NORME
INTERNATIONALE
INTERNATIONAL
STANDARD

60821

AMENDEMENT 1
AMENDMENT 1

**VMEbus –
Microprocessor system bus
for 1 byte to 4 byte data**

Figure 4-8 – Release of the interrupt request lines by ROAK and RORA INTERRUPTERS

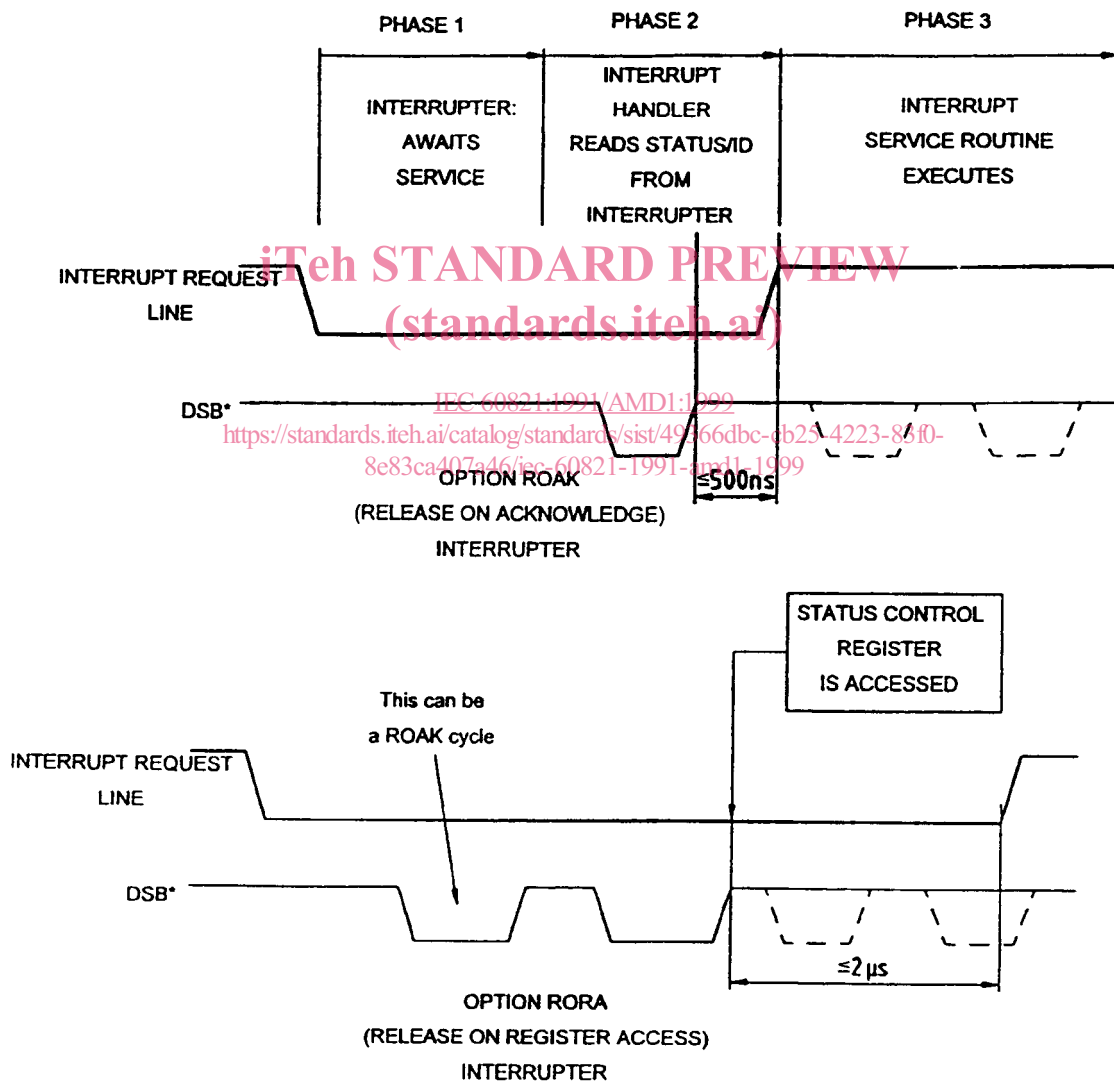
Replace figure 4-8 by the following new figure:

Figure D-5 – VMEbus arbitration structure; dashed circles indicate where critical input conditions can arise
 a) simplified block diagram;
 b) control signals, with evidence of the handshake loop (MASTER - REQUESTER - ARBITER - REQUESTER - MASTER)

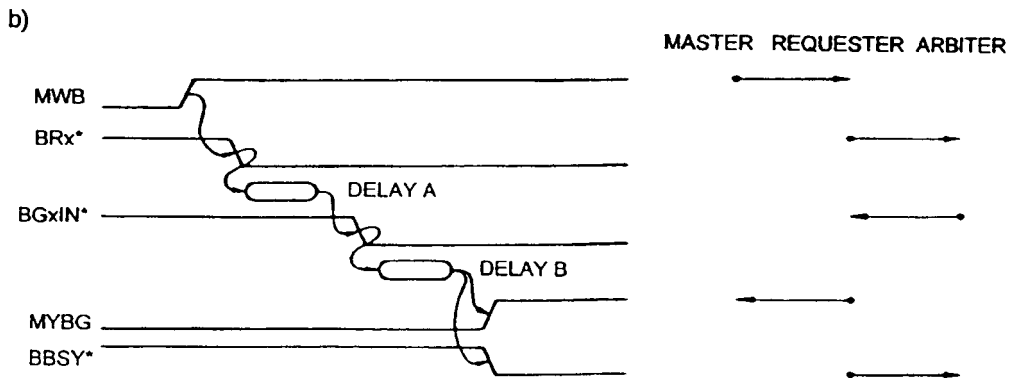
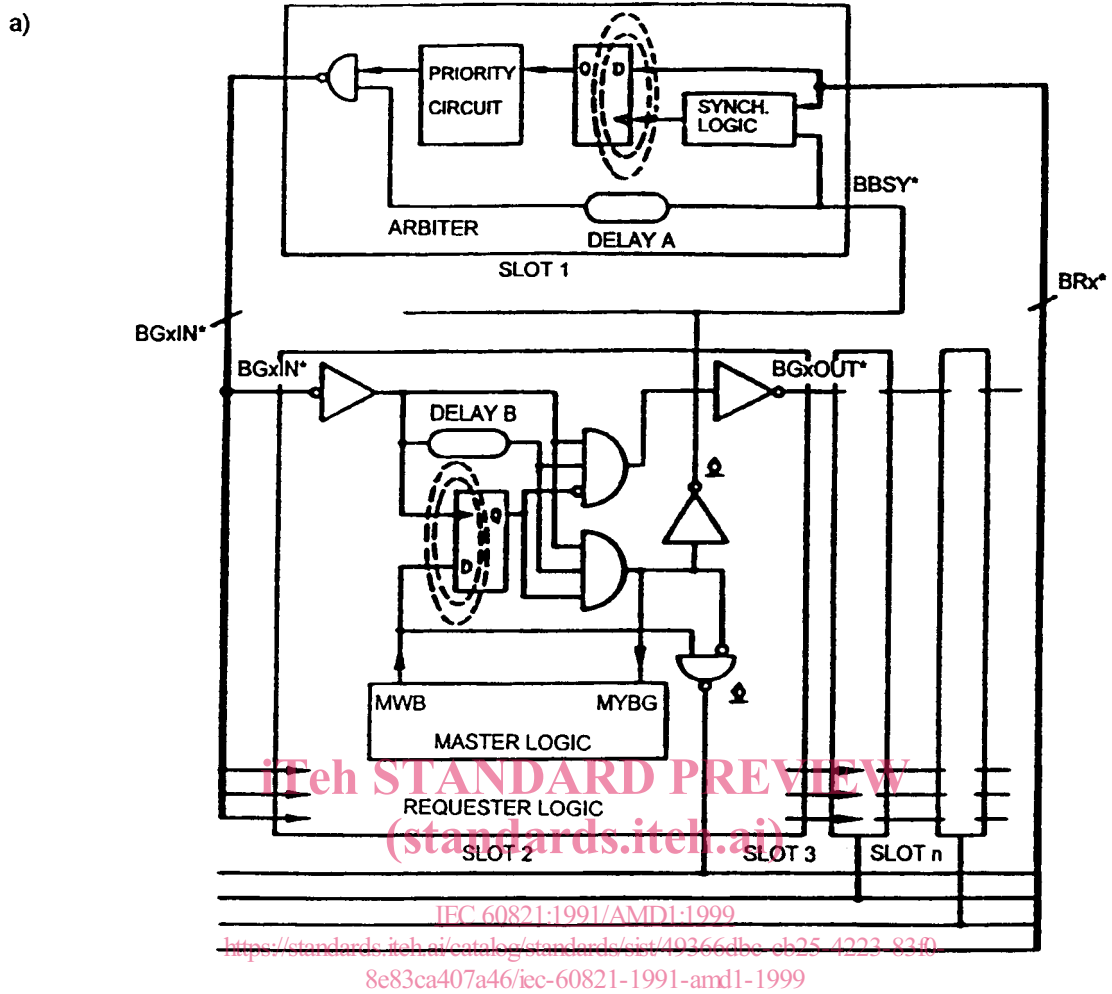
Replace, on page 527, figure D-5 by the following new figure:
